ACCESSIBILITY REPORT

BIOLOGICAL SCIENCES PROJECT STAGE 2 (SSD 6674)

**BOTANY STREET, KENSINGTON
UNIVERSITY OF NSW**

3rd November 2016

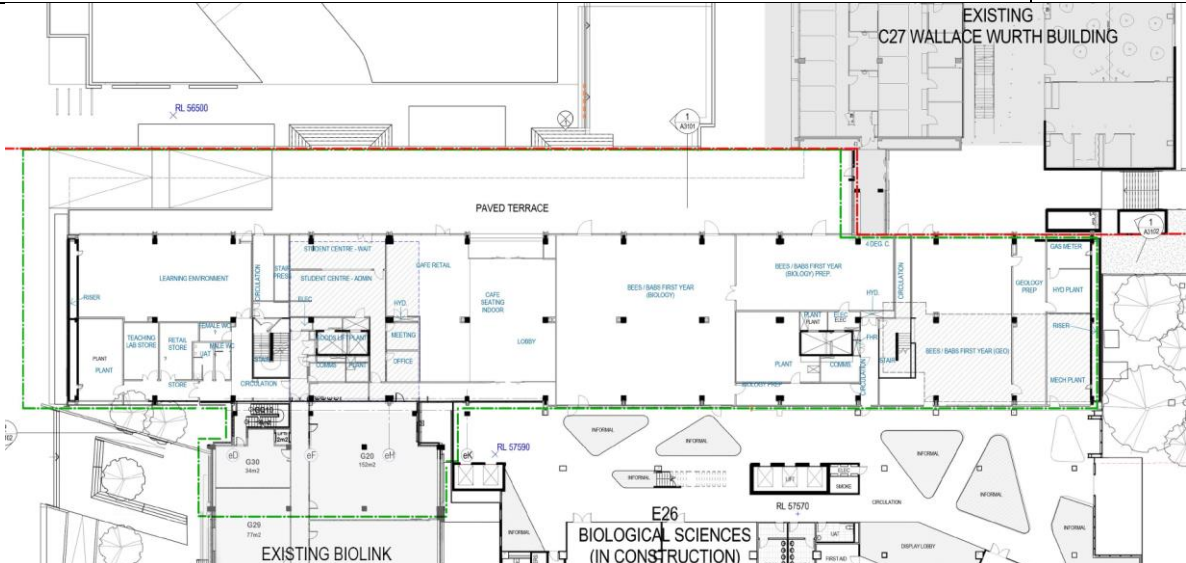
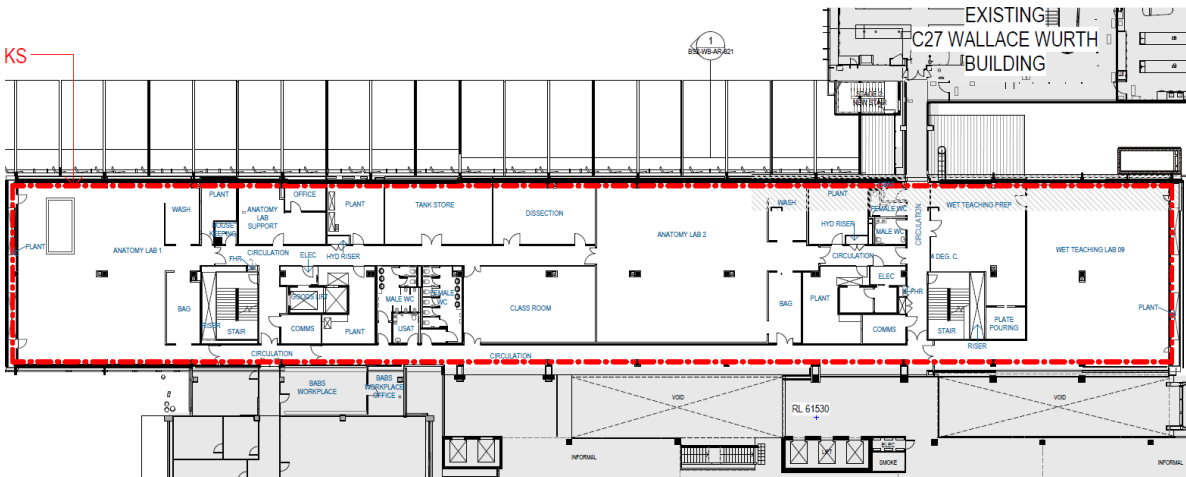
BCA / DDA Access Code Review	Complies
 <p>Plan Illustrates overall Stage 1 and 2 areas with stage 2 outlined in green</p>	
<p>Ground Floor Level</p> <p>I. Entrances – The new stage 2 building works propose;</p> <ol style="list-style-type: none"> To reconfigure the existing principal entry on the northern side of the building that incorporates a 1:20 maximum gradient walkway to access the principal building entry. The walkway provides kerbed edges to comply with ASI428.1 and access to intermediate areas to enable inclusive access to all areas. The northern approach also includes a stairway to the principal entrance, which indicates handrails and tactile ground surface indicators. The external covered awning area at the ground floor level of the building proposes some outdoor retail/cafe dining adjacent to a student centre and the principal entrance. The new entrance lobby shall enable direct access into the central foyer / circulation area of the new building at the same floor level to ensure equitable access from all approaches to the new building works. 	<p>YES</p> <p>YES</p> <p>YES</p> <p>YES.</p>

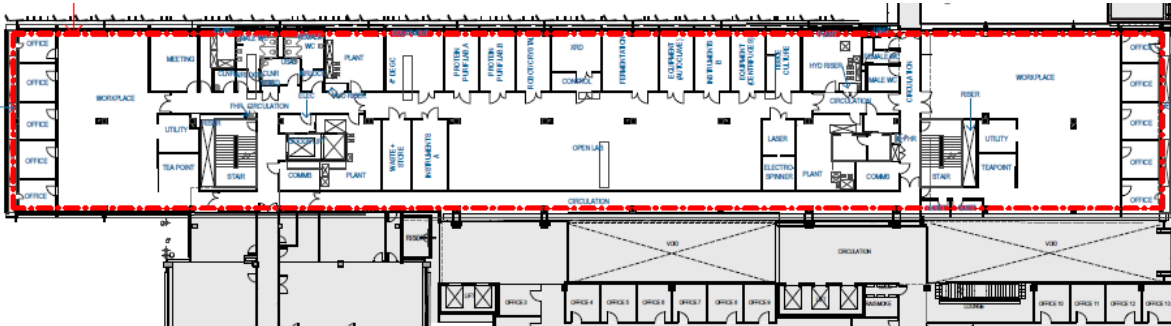
BCA / DDA Access Code Review	Complies
<p>2. The entrance stairs will be detailed with handrails, tactile ground surface indicators and other features as required by AS1428.1 and AS1428.4.1 to satisfy Parts D3.3 and D3.8 of the BCA and DDA Access Code.</p>	<p>YES at CC stage</p>
<p>3. The entrance doorways indicate double doorways with swing doors that provide circulation spaces that will comply with AS1428.1 and satisfy Part D3.2 of the BCA and DDA Access Code. Ideally, these doors will be detailed as auto sliding doors at a future design stage.</p>	<p>YES</p>
<p>4. Doors will be documented at a future stage to confirm 850mm clear opening widths, level threshold, doorway luminance contrast, glazing markings where required and doorway hardware complying with AS1428.1 to satisfy Part D3.2 of the BCA and DDA Access Code.</p>	<p>YES at CC stage</p>
<p>5. Overall, the plans illustrate appropriate access to enter the building from all approaches at the ground floor level consistent with AS1428.1 to satisfy Part D3.2 of the BCA and DDA Access Code.</p>	<p>YES</p>

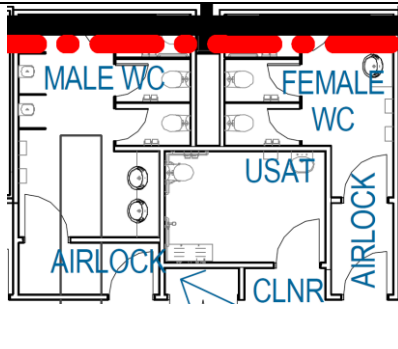
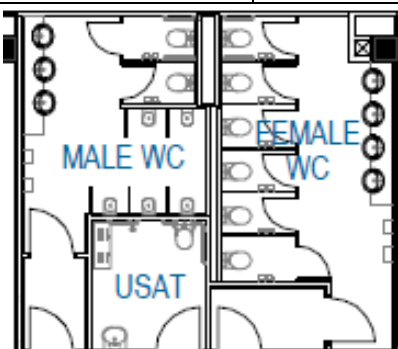
BCA / DDA Access Code Review	Complies
Lifts <p>34. Lift Installations – The Stage 2 works propose the installation of a goods lift that will travel from lower ground floor to all levels of the building will comply with Table D3.1 and Part D3.3 of the BCA and DDA Access Code.</p> <p>35. The goods lift car requires at least 1400mm X 2000mm to comply with Part E3.6 of the BCA and DDA Premises Standards for a lift that travels 25 metres.</p> <p>36. Emergency Egress Lifts - It is noted that Stage 1 provides at least one passenger lift designed for use during a fire evacuation.</p>	<p>YES</p> <p>YES</p>
Stairways <p>37. Stairways (Non Fire Isolated) - In accordance with part D3.3(a)(ii) of the BCA the non fire-isolated stairs will be detailed at construction certificate stage with handrails on both sides, closed raisers with no overhanging lips and luminance contrasting step nosings to the requirements of AS1428.1 to satisfy Parts D3.3(a)(ii) of the BCA and be slip resistant to P4 or R11 for outdoor stair as specified by Table D2.14 of the BCA.</p>	<p>YES at CC stage</p>
